**Comments on CTV II Computational Modeling**  
**Class VI Pre-Construction Permit Application No. R9UIC-CA6-FY22-4.1-4.5**

This Computational and Static Modeling Evaluation report for the proposed Carbon TerraVault II (CTV) Class VI geologic sequestration project summarizes EPA's review of the computational modeling performed by CTV as described in the Narrative Report (Attachment A, Version 3.1) and the Area of Review and Corrective Action Plan (AoR CAP) (Attachment B, Version 3.2). Clarifying questions or requests that require further work are provided below in **bold, italic** text. Text that is not **bold, italic** is provided to give background information or is recommended for further work.

Schematic based on Fig 2.2-4 of the Narrative

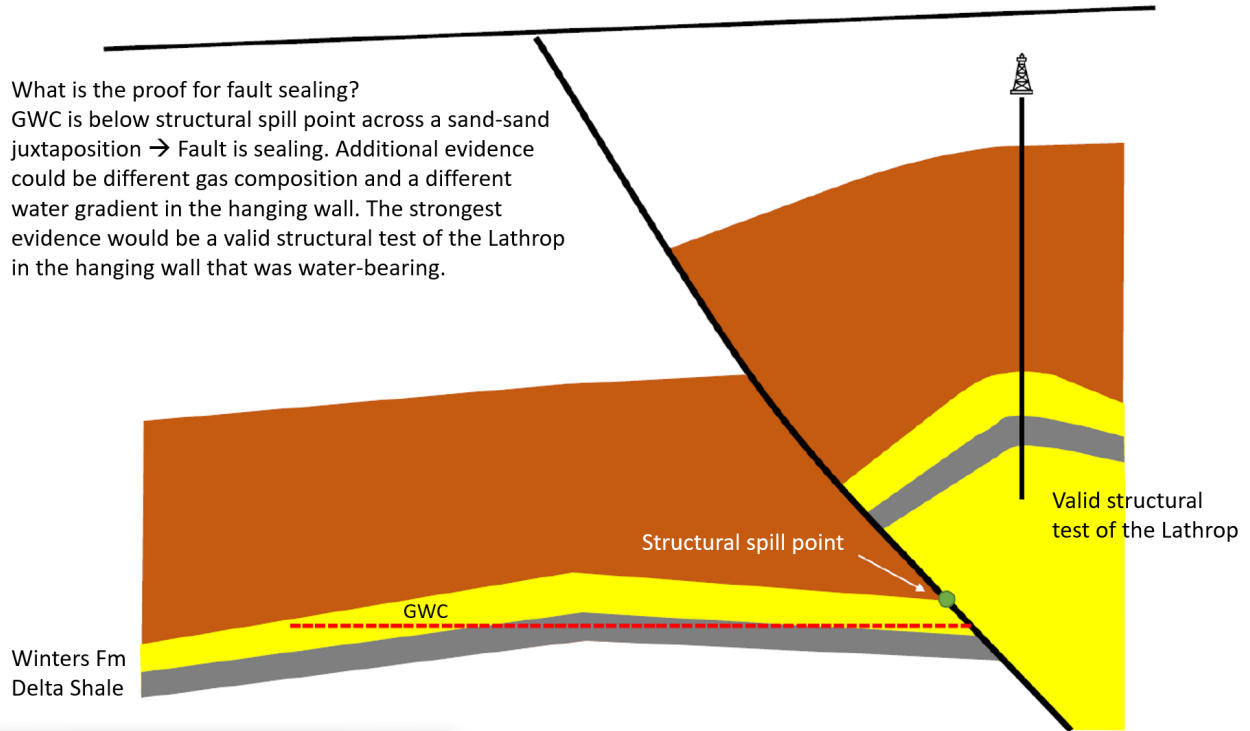
Sand-shale juxtaposition → Juxtaposition seal

More shale below  
the Delta? →  
Juxtaposition seal

Sand-sand juxtaposition

Lathrop Sand →  
More info  
needed

What is the proof for fault sealing?

What is the proof for fault sealing?

GWC is below structural spill point across a sand-sand juxtaposition → Fault is sealing. Additional evidence could be different gas composition and a different water gradient in the hanging wall. The strongest evidence would be a valid structural test of the Lathrop in the hanging wall that was water-bearing.

GWC is controlled by a structural spill point on the fault → Fault is leaking, unless a valid structural test of the Lathrop in the hanging wall, that is on the fill-spill chain, was water-bearing.
